# WESTWOOD SHOPPING CENTER

SITE PLAN NO. 82018019A  
AMENDMENT

SITE PLAN –  
COMPOSITE

## AMENDMENT SUMMARY #82018019A

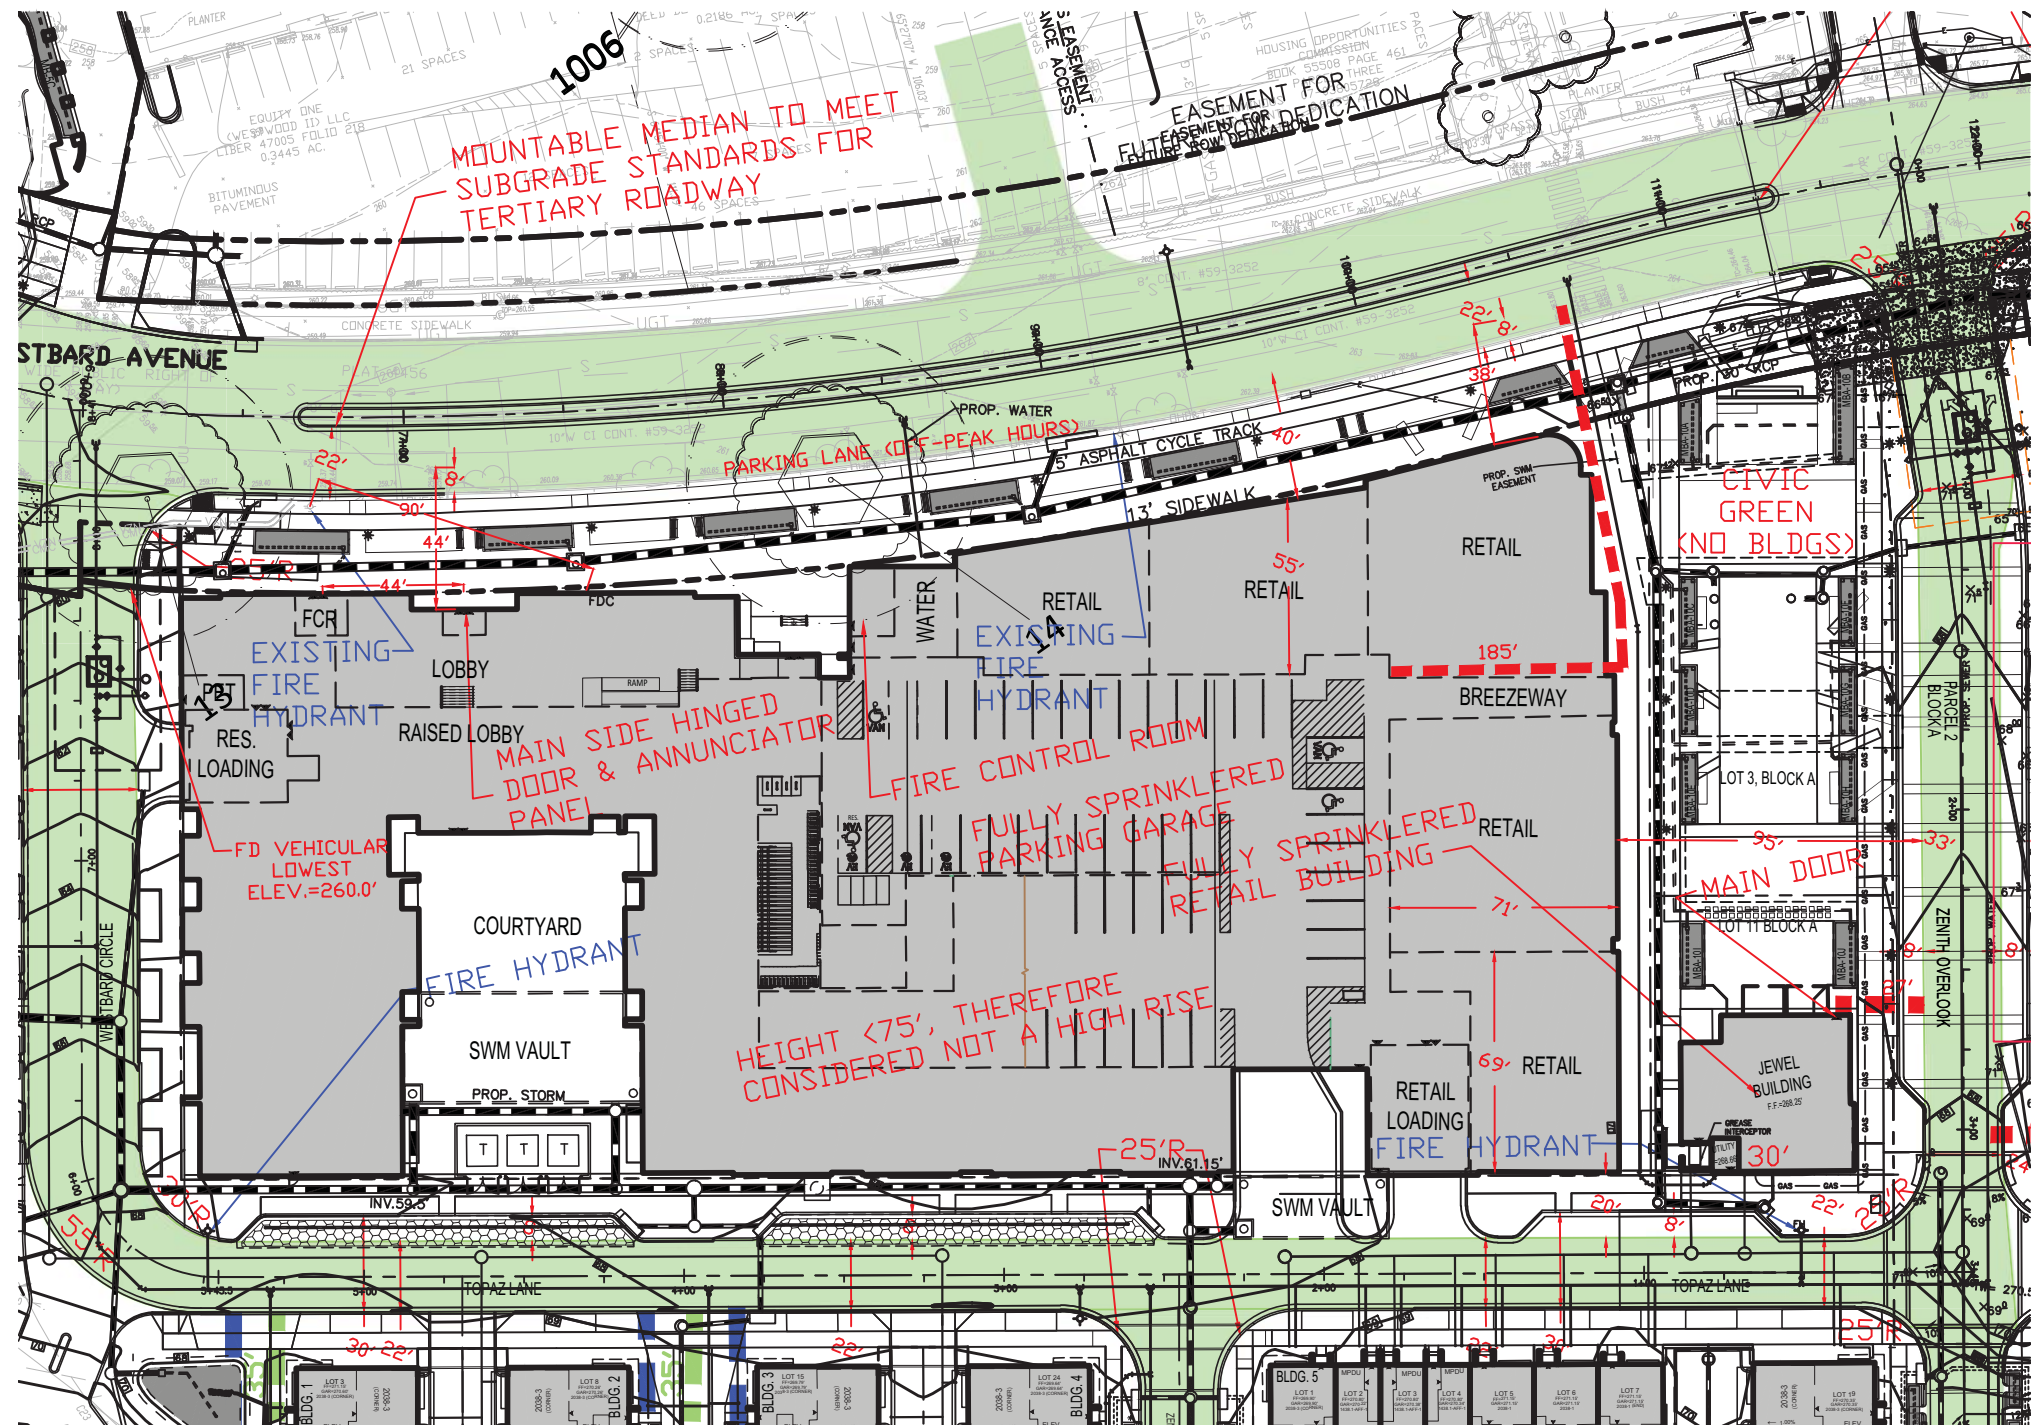
There are small changes in Fire Department Access, however the building will continue to be served by FDA compliant public and private roadways to the east, south, west and north.

There will be a change in the main lobby/fire control room and FDC, however the access doors will remain to be within 50' of an FDA and the FDC will remain to be within 100' of a fire hydrant (i.e. no negative impact to the changes being made. This approval is also seeking approval of a statement of performance based design for the future retail spaces. See attached sketch reflecting the change listed above.
